TECHNICAL BULLETIN

NO. 407-97-6

MODELS AFFECTED: 407

SUBJECT: FADEC/ECU AND LITTON INSTRUMENT,
(DOWNLOAD CABLES), MODIFICATION OF.

Figure 1. FADEC/ECU download cable - Diagram

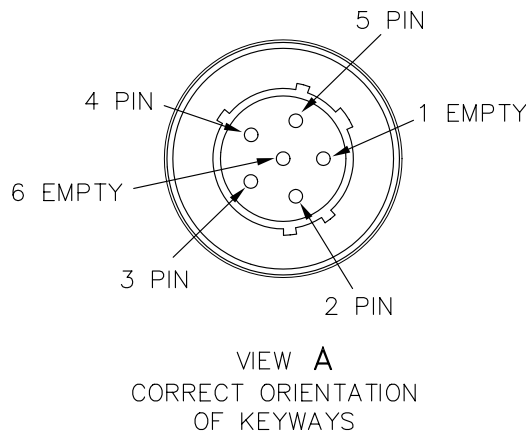
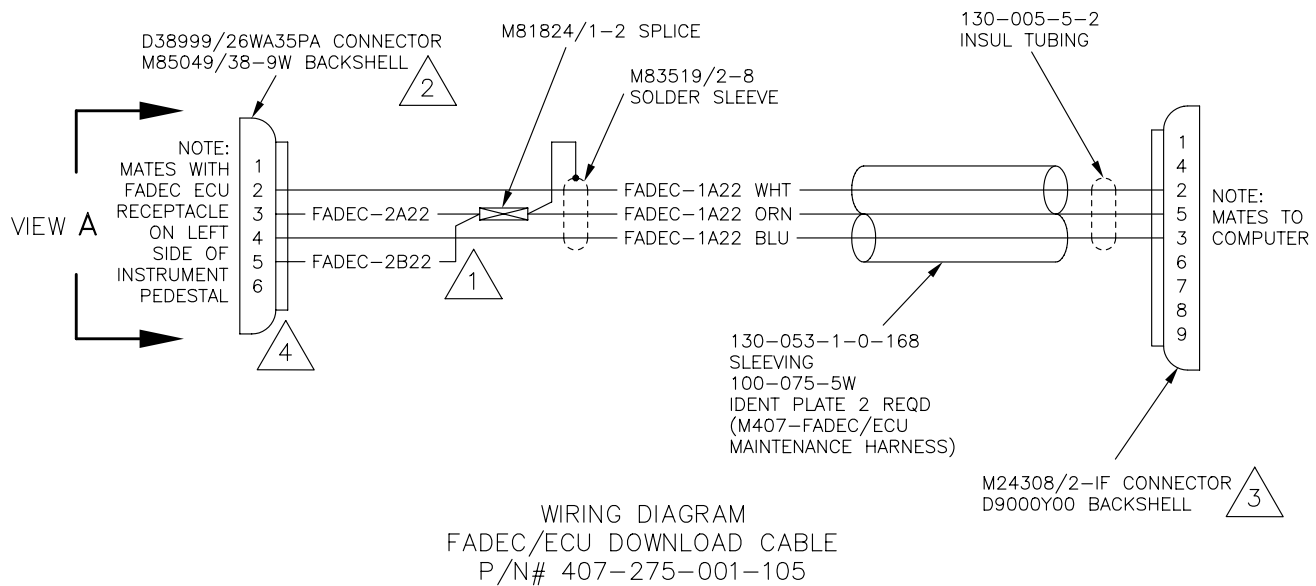
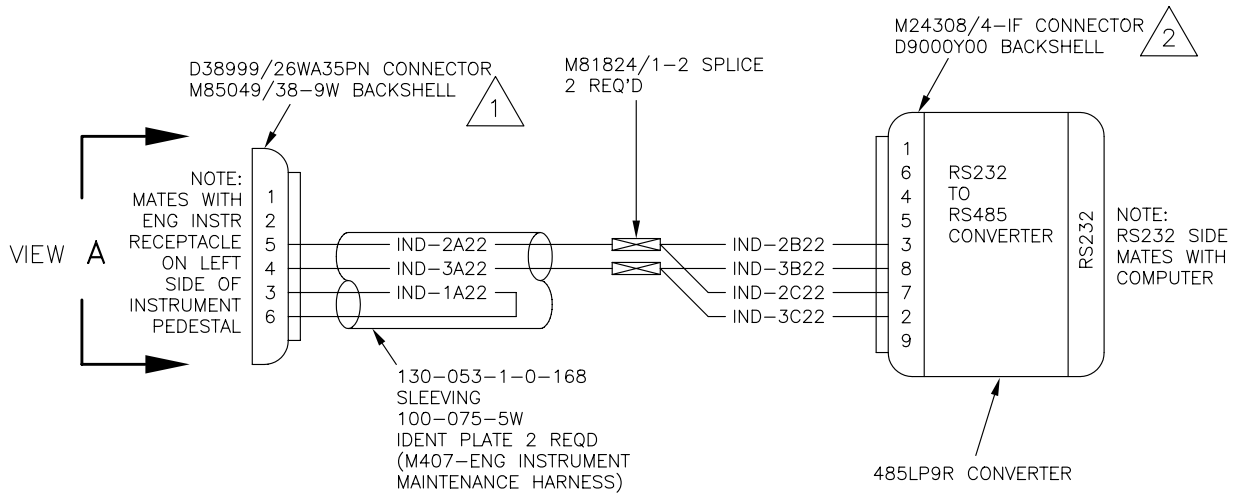
DESCRIPTION: Bell Helicopter has found that some of the FADEC/ECU download cables, P/N: 407-275-001-101/-105, used to download FADEC/ECU data can have their wires incorrectly installed by the manufacturer.

1. With the use of an Ohmmeter, make sure that the wires are installed as shown on wiring diagram in Figure 1. If the wires are not installed as shown on Figure 1 then remove each of the wires and re-install correctly. If wire FADEC-2B22 is attached to the connector backshell with a terminal end, then the harness must be modified. Refer to Step 4.

2. Make sure that the keyways of the harness connector that attaches to the airframe FADEC/ECU receptacle are the same as shown on Figure 1, View A. If the keyways are not the same as the ones shown on Figure 1, View A, replace the connector. Refer to Step 4.

4. Rework the FADEC/ECU download cable, P/N 407-275-001-101, to the new configuration of the FADEC/ECU download cable, P/N 407-275-001-105, as follows:

- a. On the connector that attaches to the airframe FADEC/ECU receptacle, remove the screw that attaches the terminal lug, P/N MS25036-102, to the backshell of the connector (wire FADEC-2B22).

- b. Cut the terminal lug to remove it from the wire FADEC-2B22.

- c. Disassemble the connector. With the use of an insertion/removal tool, remove all of the pins from the connector.
 - d. Cut all of the wires to an equal length. Strip the wires in preparation for crimping. Refer to BHT-ELEC-SPM.
 - e. With the use of a crimping tool and positioner, install a pin at the end of each of the wires. Refer to BHT-ELEC-SPM, for the installation of pins.
 - f. Install the pins in the connector to their respective location as shown on the diagram on Figure 1.
 - g. Assemble the connector and install the backshell.
5. Re-identify the FADEC/ECU download cable to the new configuration Part Number, 407-275-001-105.

Figure 2. LITTON instrument download cable - Diagram

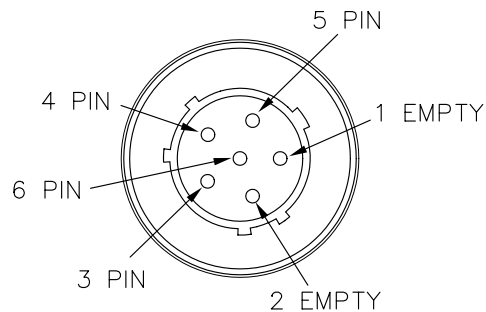
Bell Helicopter has also found that some of the LITTON cables, P/N: 407-275-001-103, used to download LITTON instrument data can also have their wires incorrectly installed by the manufacturer.

- 1. With the use of an Ohmmeter, make sure that the wires are installed as shown on wiring diagram in Figure 2. If the wires are not installed as shown in Figure 2, then remove each wire and re-install correctly.
- 2. Make sure that the keyways of the harness connector that attach to the airframe engine instruments receptacle are the same as the keyways shown on Figure 1, View A. If the keyways are not the same as the ones shown on Figure 2, View A, replace the connector. Refer to Part I, Steps 4.b. to 4.g.
- 3. Remove and install the pins of the LITTON instrument download cable as shown on the diagram on Figure 2.
- 4. If the wires are installed as shown on Figure 2 (Step 1) and the keyways of the harness connector are the same as shown in Figure 2 View A (Step 2), no modification is required.
